TECHNICAL SERVICE BULLETIN

SUBJECT:
Engine Buck, Surge Or
Noise - Oil Pump Drive
Gear Wear

NO.: 18-08-93 Rev. A
GROUP: Driveability
DATE: Nov. 26, 1993

THIS BULLETIN SUPERSEDES TECHNICAL SERVICE BULLETIN 18-08-93, ISSUED ON 6/18/93, WHICH SHOULD BE REMOVED FROM YOUR FILES. THIS BULLETIN ADDS CAUTIONS TO THE PROCEDURE, WHICH ARE HIGHLIGHTED WITH **ASTERISKS AND PRINTED IN RED.**

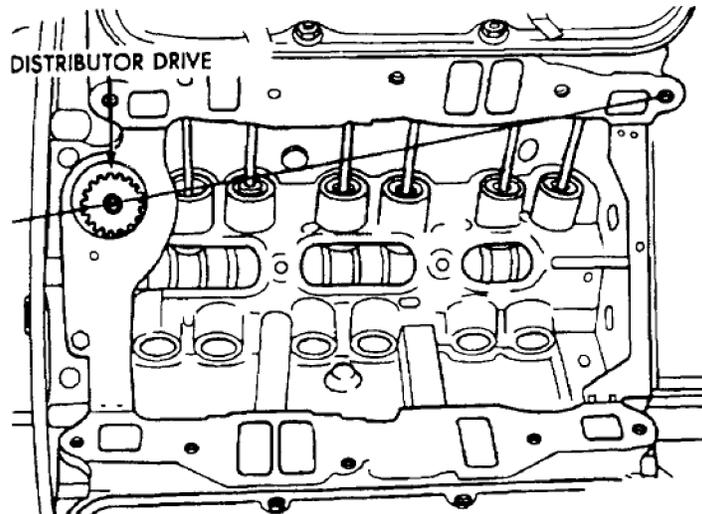
****NOTE:** TOOL NUMBER C-3052 (DISTRIBUTOR DRIVE SHAFT BUSHING PULLER) MUST BE USED TO REMOVE DISTRIBUTOR/OIL PUMP DRIVE GEAR AND TOOL NUMBER C-3053 (DISTRIBUTOR DRIVE SHAFT BUSHING DRIVER/BURNISHER) MUST BE USED TO INSTALL THE NEW DISTRIBUTOR/OIL PUMP DRIVE GEAR BUSHING.**

****NOTE:** THE CORRECT POSITION FOR THE DISTRIBUTOR/OIL PUMP DRIVE GEAR BUSHING IS SHOWN BELOW.**

2. Install new drive gear block bushing P/N 01737725 and revised oil pump drive gear P/N 53020546 as outlined in the appropriate service manual.
